SUBJECT: Memorandum to the Site File for OUB/Poleline Road Disposal Area

MEMORANDUM TO THE SITE FILE
FOR LONG TERM MONITORING AT THE
POLELINE ROAD DISPOSAL AREA, OPERABLE UNIT B

JBER Richardson, ALASKA

II. OBJECTIVES OF THIS REVISION TO THE OUB/POLELINE ROAD LONG-TERM MONITORING PLAN

Figure B
Long Term Monitoring Network
ANNUAL WELLS

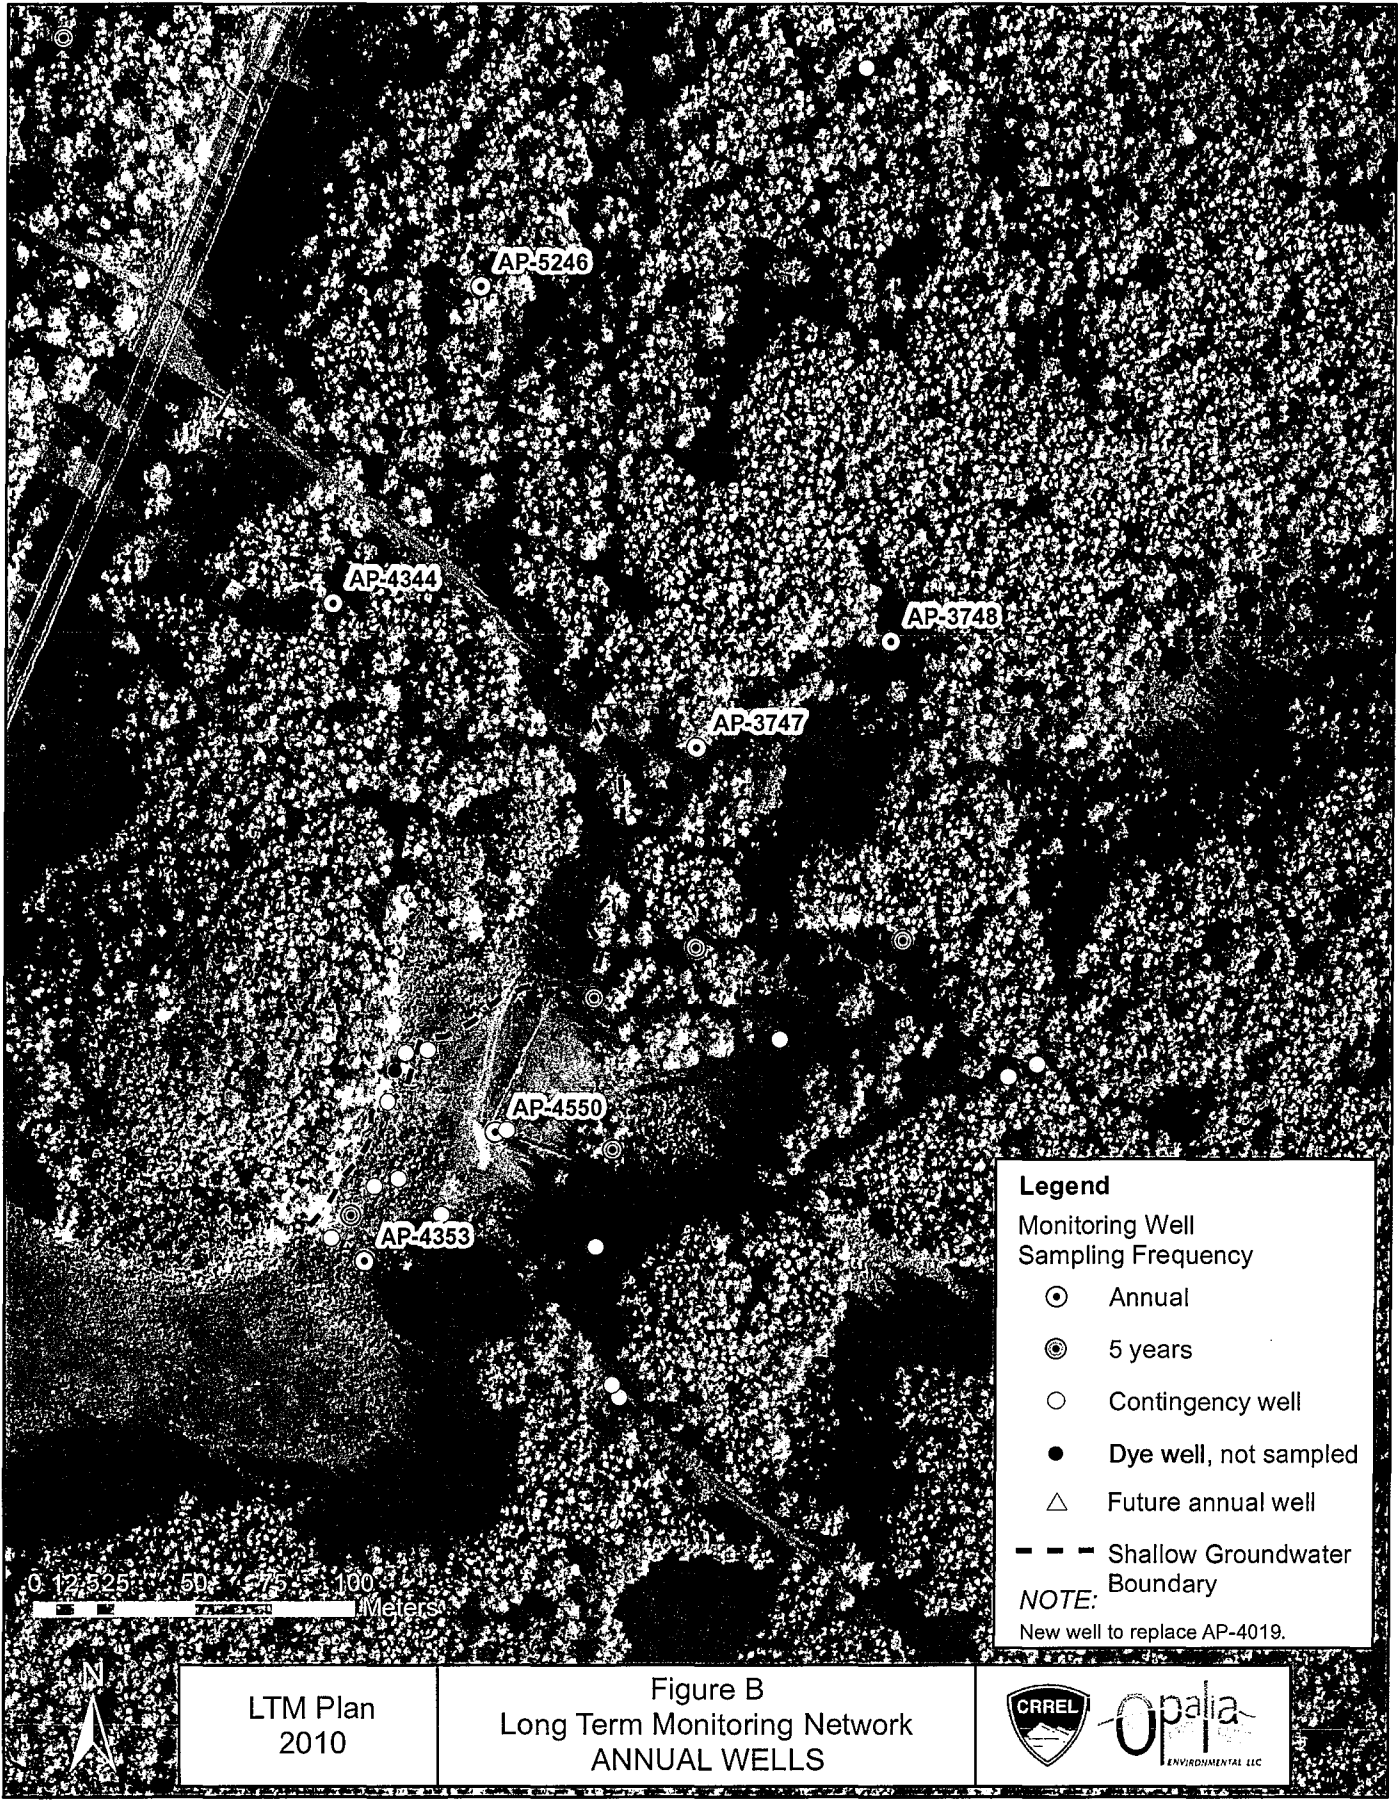
routine, "annual" sampling. These wells are listed in TABLE B and shown in FIGURE B. If, in the course of annual monitoring of the regional/deep aquifer, it is determined that contaminant concentrations are increasing significantly, up to an additional 14 monitoring wells can be added to the sampling network to verify these trends, measure changes in contaminant plume concentrations, and the spatial extent of the plume. These additional wells are referred to as "contingency" wells and are listed in TABLE C and shown in FIGURE C. Sampling should occur when the water table is at its annual peak when possible (usually in the fall) to ensure the maximum concentrations are being monitored long-term. The determination to add some or all of the "contingency" wells to the next annual sampling event would be based on "weight of evidence" criteria rather than on a specific numerical criterion. The Remedial Project Managers will review each annual sampling report and decide (based on the data and information in that report and those of preceding sampling years) whether and to what extent to include "contingency" wells in the next upcoming monitoring event.

AP-4019 is a regional well co-located with AP-3747 and immediately downgradient of the "hot spot." The screen interval in this well was constructed to be 30 feet. This is too great a length to allow specific analysis of the aquifer source of any measured contaminants. Therefore, this well will be re-drilled (very close to the existing well) upon receipt of funding. This is expected to occur in the summer of 2011 prior, it is hoped, to the time of the 2011 annual groundwater sampling. The replacement well here will be constructed with a more carefully positioned five foot screen interval.

NOTE:
New well to replace AP-4019.

Figure C
Long Term Monitoring Network
CONTINGENCY WELLS

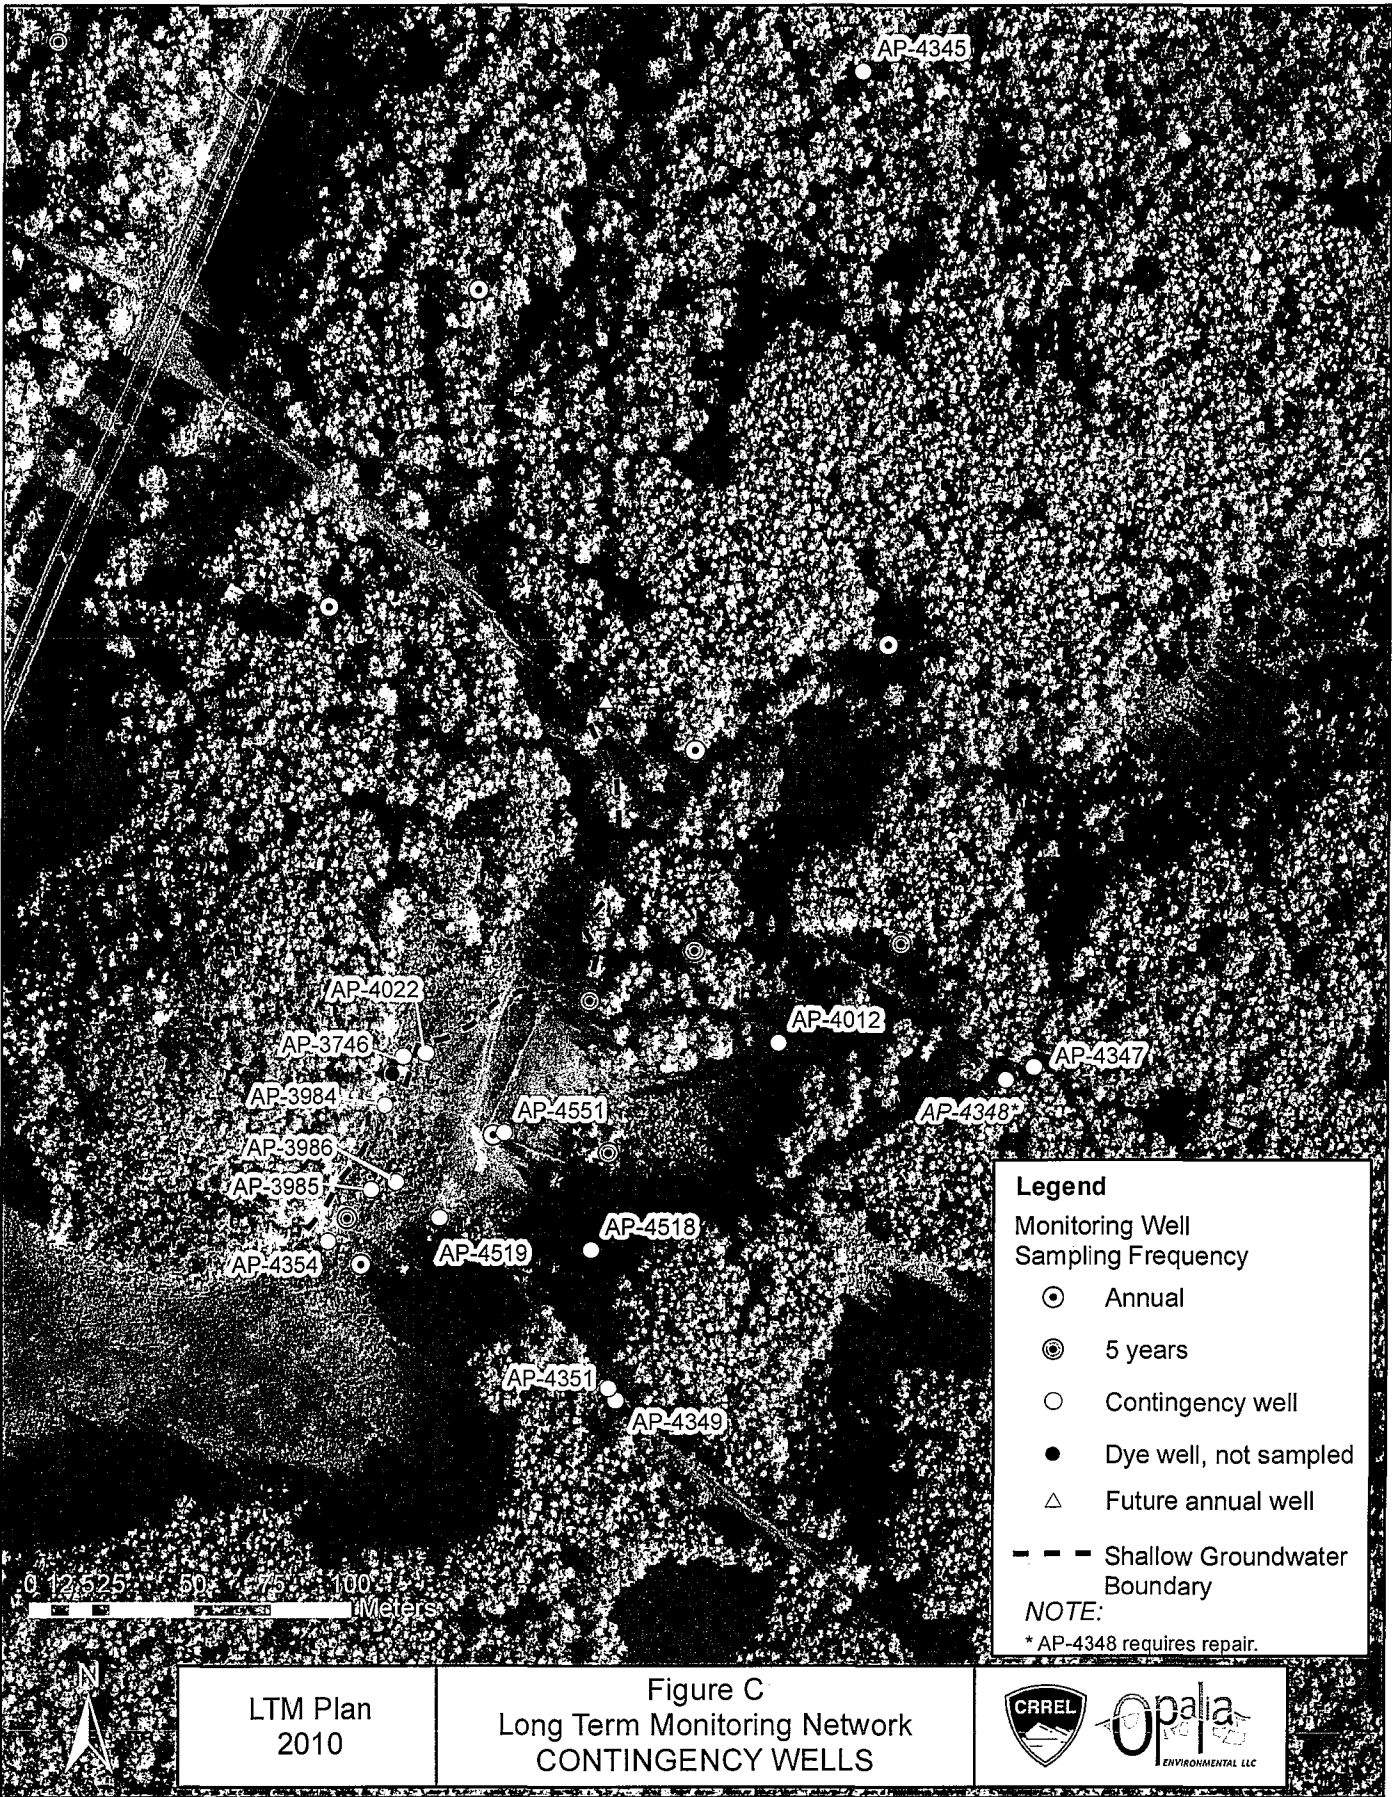
AP-4347 and AP-4349 are "contingency" wells, they are located in the regional aquifer to the south and southeast of the shallow plume, respectively. These wells had trace contamination when sampled in June 2003. They will be sampled again in 2010 in order to confirm that there is no regional plume in this area. The frequency of sampling here is contingent on 2010 sampling results.

NOTE:
* AP-4348 requires repair.

Figure D
Long Term Monitoring Network
5 YEAR WELLS

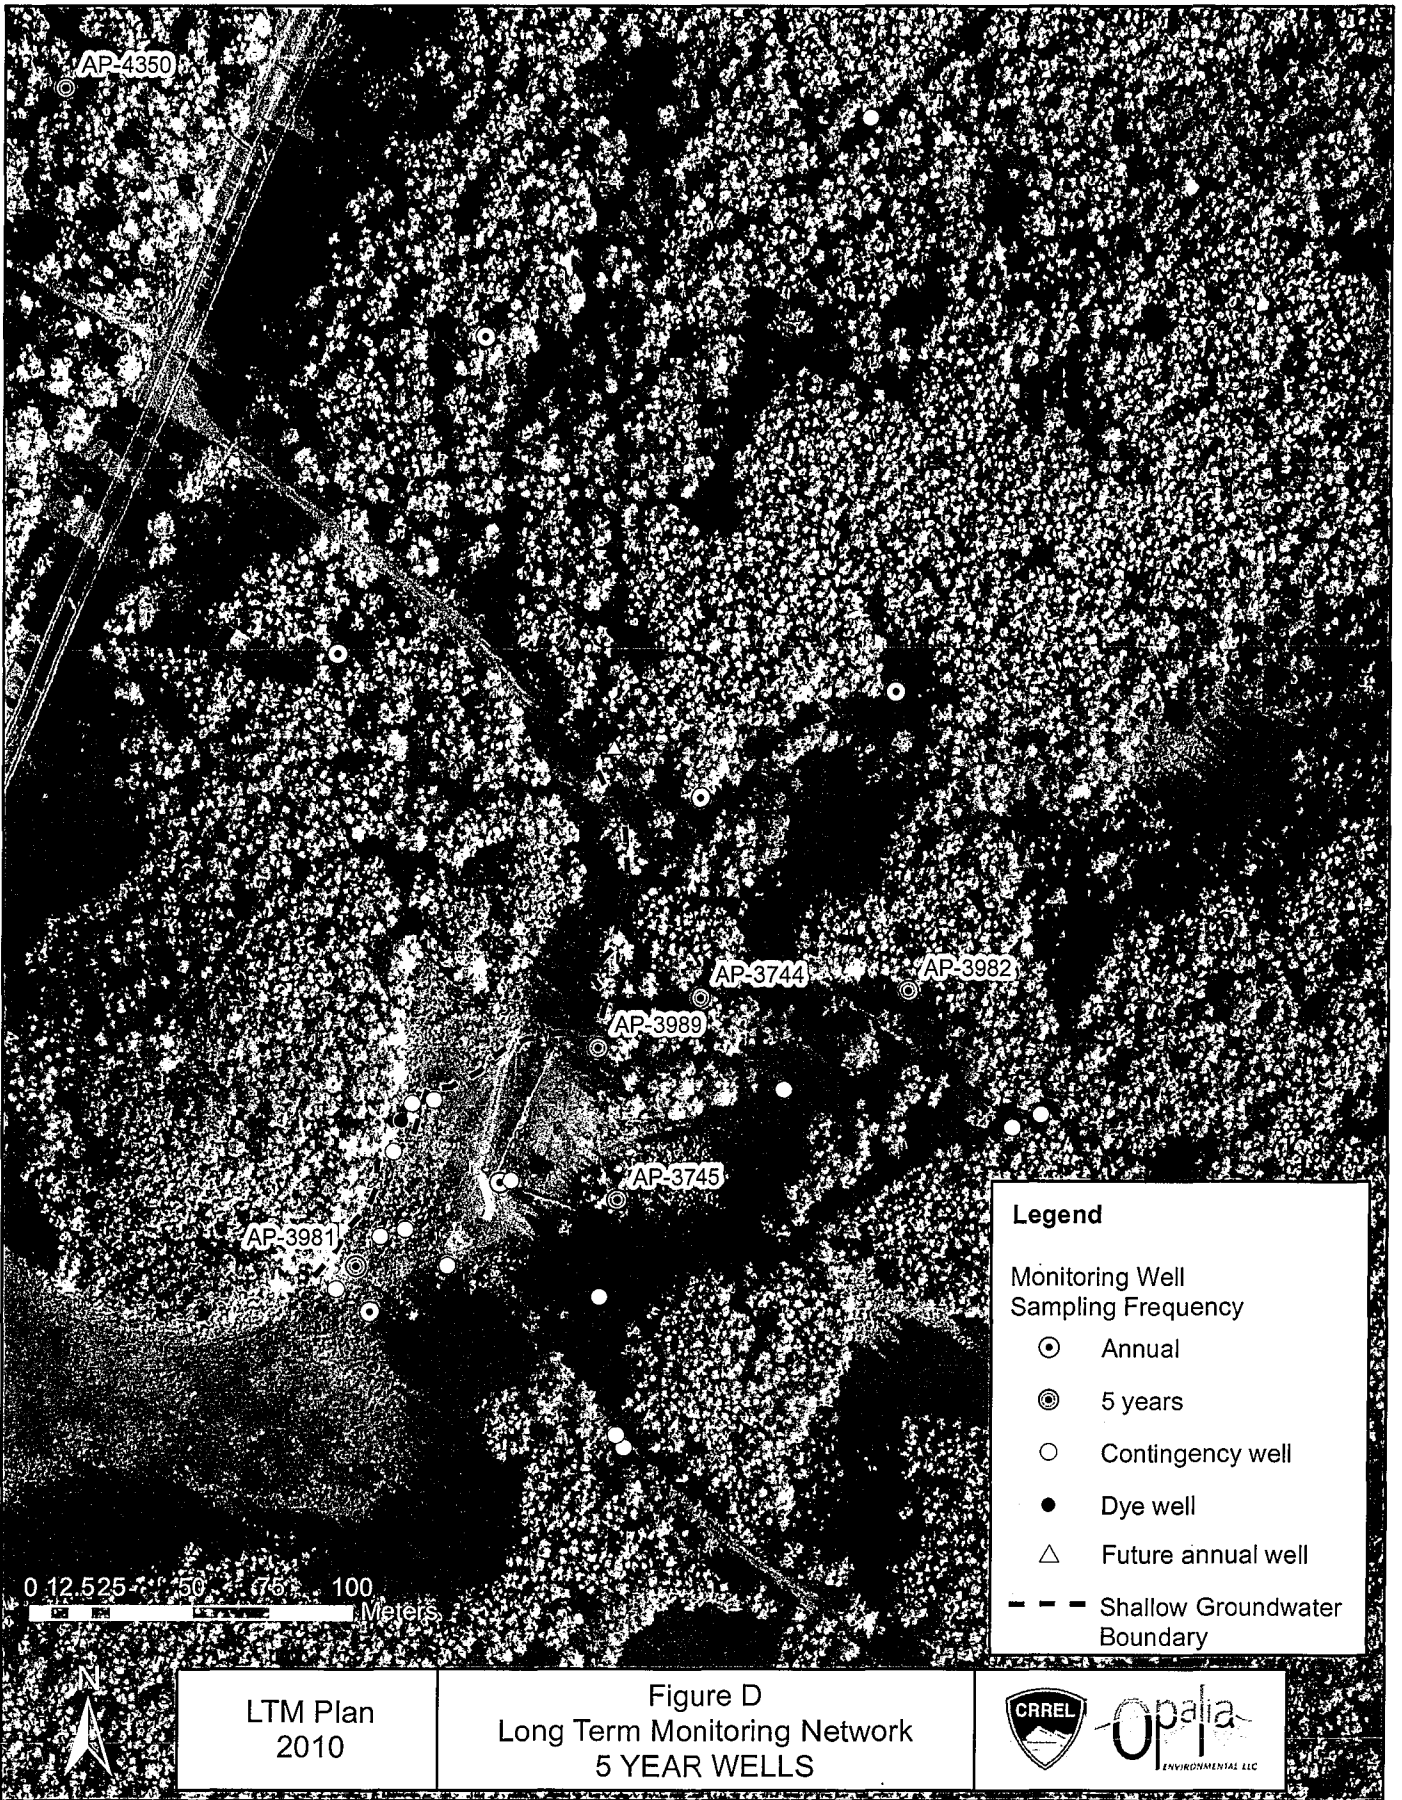
To insure that longer-term trends are not missed, six wells (listed in TABLE D and shown in FIGURE D) will be sampled in the year prior to the next Five Year Review (2012) and the year prior to each succeeding Five Year Review. These results will be reported with the "annual" well report in those years' reports.

Figure E
Long Term Monitoring Network
WELLS TO DECOMMISSION

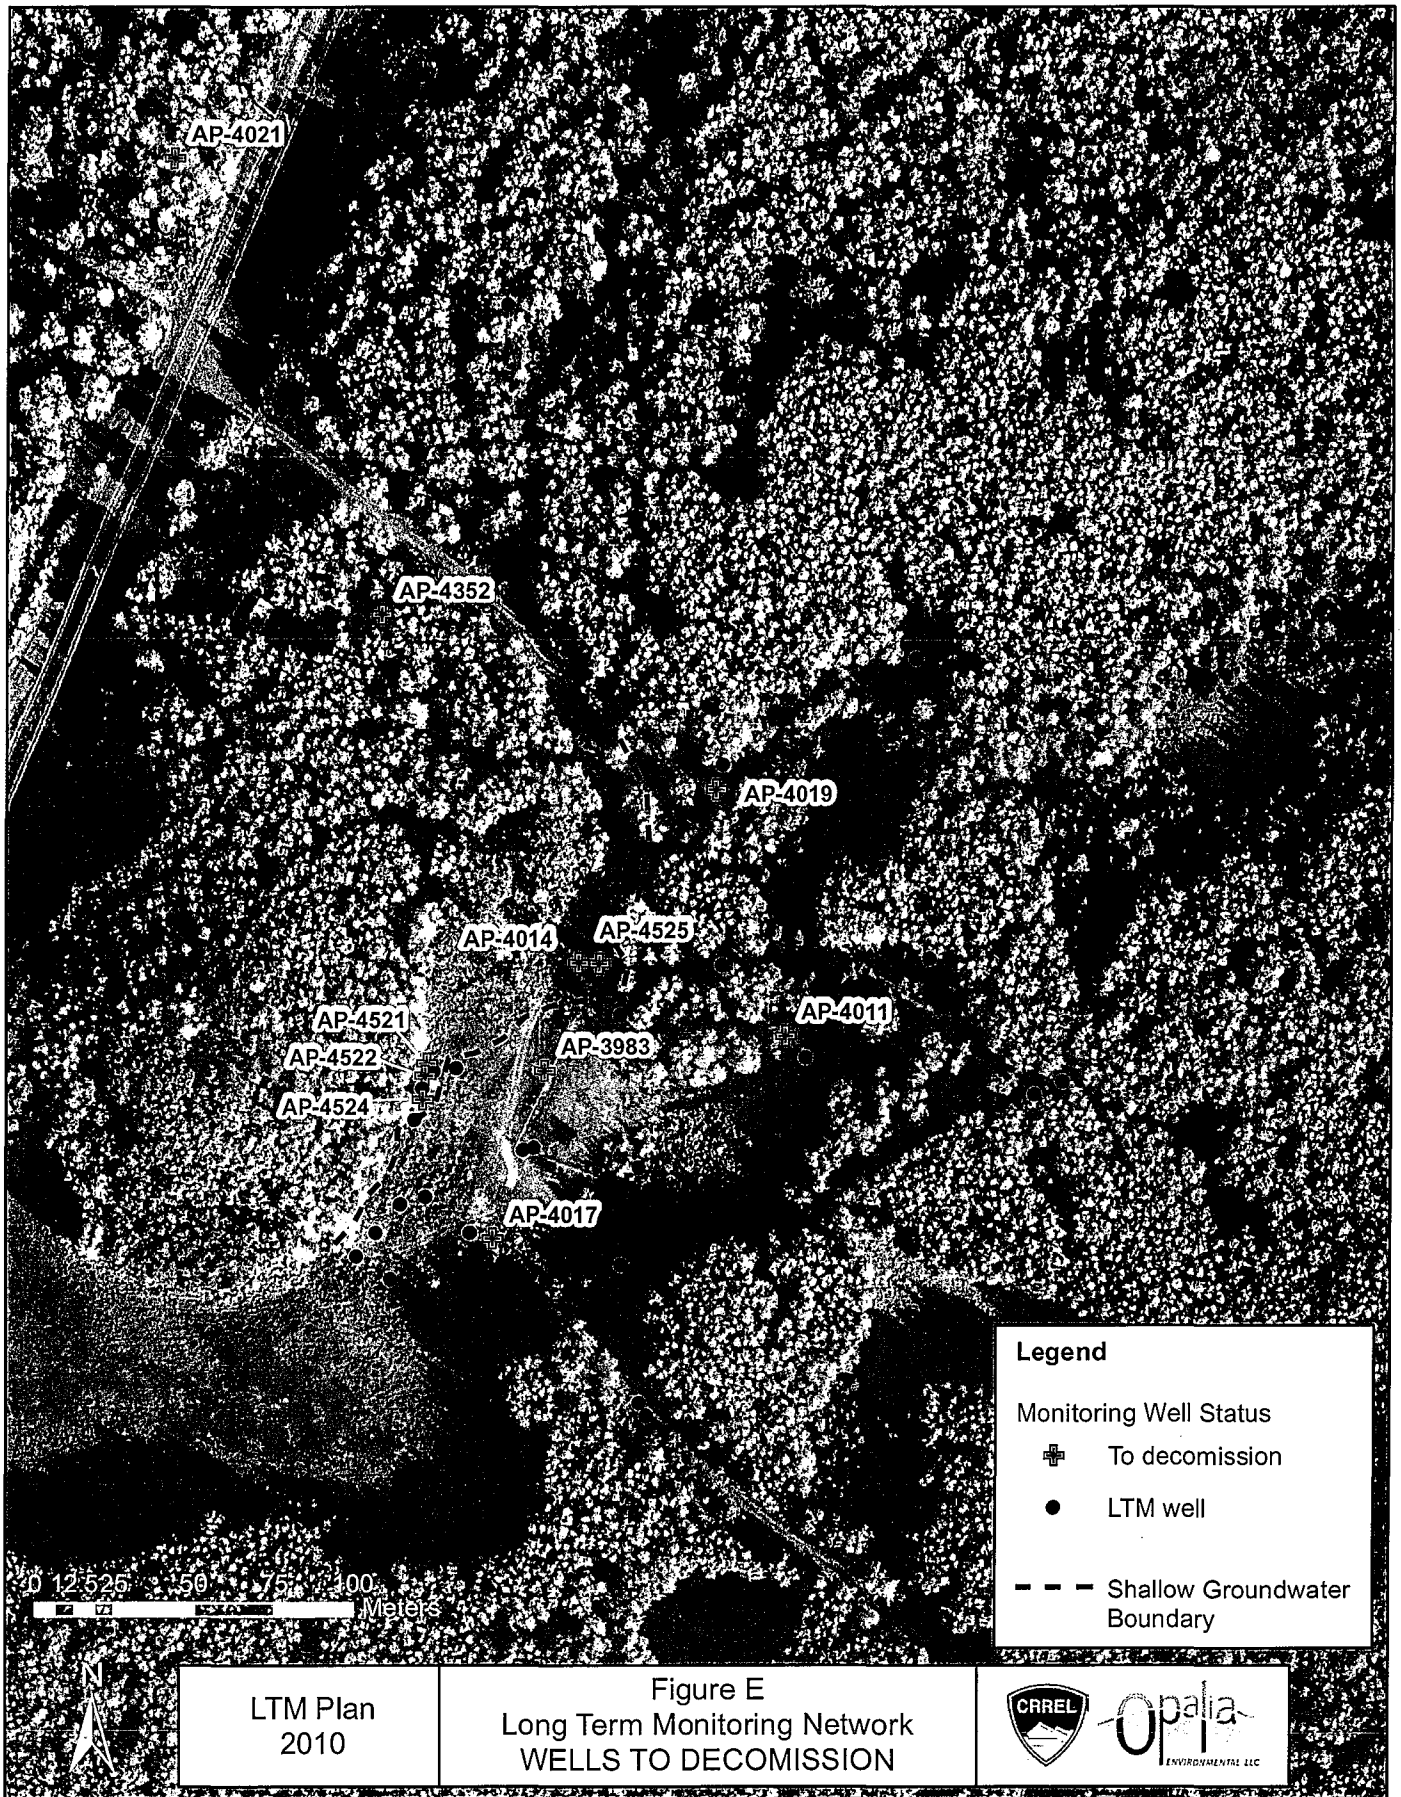
It is the intent of the LTM Plan to decommission eleven wells, inasmuch as it has been determined that these wells no longer provide adequate or useful data for the purposes of the LTM Plan. These wells are listed in TABLE E and shown in Figure E.
